STAFF RECOMMENDATION

NCPC File No. Z.C. 06-13

CONSOLIDATED PLANNED UNIT DEVELOPMENT AND MAP AMENDMENT FOR A MIXED-USE DEVELOPMENT AT 1000 CONNECTICUT AVENUE, NW

Square 163, Lots 803-806 and 847
Washington, D.C.

K STREET FAÇADE

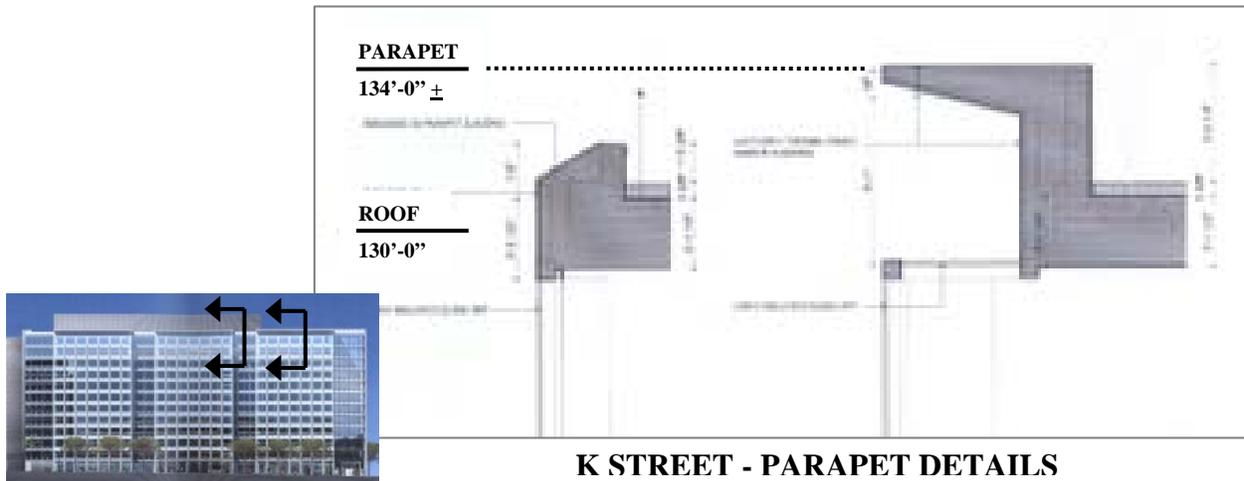
Staff finds that the parapet heights along the K Street and Connecticut Avenue façades are in conflict with the federal Height of Buildings Act of 1910. Section 5 of the Height Act states that “No building shall be erected, altered, or raised in any manner as to exceed the height of one hundred and thirty feet...” and Section 7 of the Act states that, “no parapet walls shall extend above the limit of height.”

Based on the architectural drawings included in the submission, the top elevation of the parapet is approximately four feet (4') above the allowable height of 130 feet; if the parapet were set back from the edge or the roof at a 1:1 height/setback ratio, however, it could be constructed within the requirements of the Act.

Staff therefore recommends that the Zoning Commission require the applicant to modify the design to eliminate the parapet, or set it back from the exterior walls to distances equal to their respective heights above the adjacent roof.

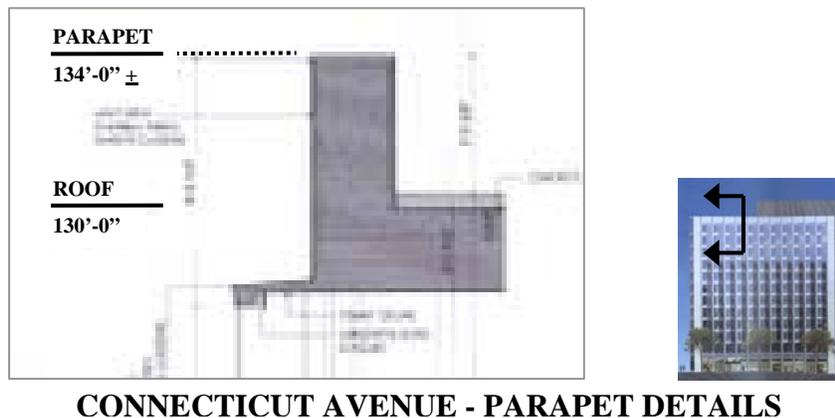
A penthouse at the middle of the roof also exceeds the façade plane height restriction; however, since the penthouse is set back from the roof within the required 1:1 ratio established by the Height of Buildings Act, staff finds the penthouse to conform to the Act's requirements.
